## UNITED STATES PATENT AND TRADEMARK OFFICE

APPLICATION NO.	FILING DATE	FIRST NAMED INVENTOR	ATTORNEY DOCKET NO.	CONFIRMATION NO.
10/576,560	11/06/2006	Olle Hemmingson	1000500-000385	3806
21839 7590 11/03/2009 BUCHANAN, INGERSOLL & ROONEY PC POST OFFICE BOX 1404 ALEXANDRIA, VA 22313-1404				
EXAMINER				
PATEL, BHARAT C				
ART UNIT		PAPER NUMBER		
3724				
NOTIFICATION DATE		DELIVERY MODE		
11/03/2009		ELECTRONIC

### Office Action Summary

HEMMINGSON, OLLE

FIG. 5

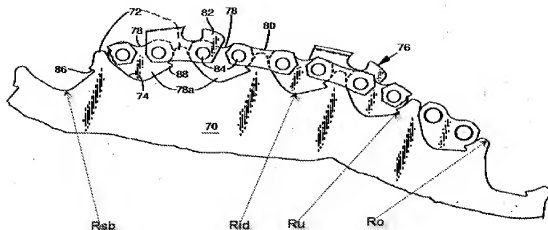
Re claim 2, Carlton teaches that the cam surface 88 on each driving link 78 is designed to press the chain 76 radially outwards against the radial projection 86 by the cam effect, in such a way that, in a tensioned state, the chain is held onto the disk 70 as a result of its shape per Fig. 5 and per col. 4, lines 3-36.

Re claim 4, Carlton teaches that the bottom 74 of the groove has a predetermined number of projections 86 distributed evenly around the circumference of the disk 70 per Fig. 5.

Re claim 5, Carlton teaches that the bottom 74 of the groove has one projection 86 for each driving link 78 per Fig. 5.

Re claim 6, Carlton teaches that radial cross-section of each projection 86 is lug shaped per Fig. 5.

Re claim 7, Carlton teaches that radial cross-section of each projection 86 is pyramid shaped per Fig. 5.

Re claim 8, Carlton teaches that radial cross-section of each projection 86 is dome shaped per Fig. 5.

Re claim 9, Carlton teaches that radial cross-section of each projection 86 is designed as a truncated cone that has a complementary shape to the cam surface 78a of the interacting driving link 78 per Fig. 5.

Re claim 11, Carlton teaches that the construction of the chain 76 is such that the connecting links 80 are spaced radially outwardly with respect to radially outermost portions of the radial projections 86 when the chain is in the neutral position, and when the chain is being driven per Fig. 5.
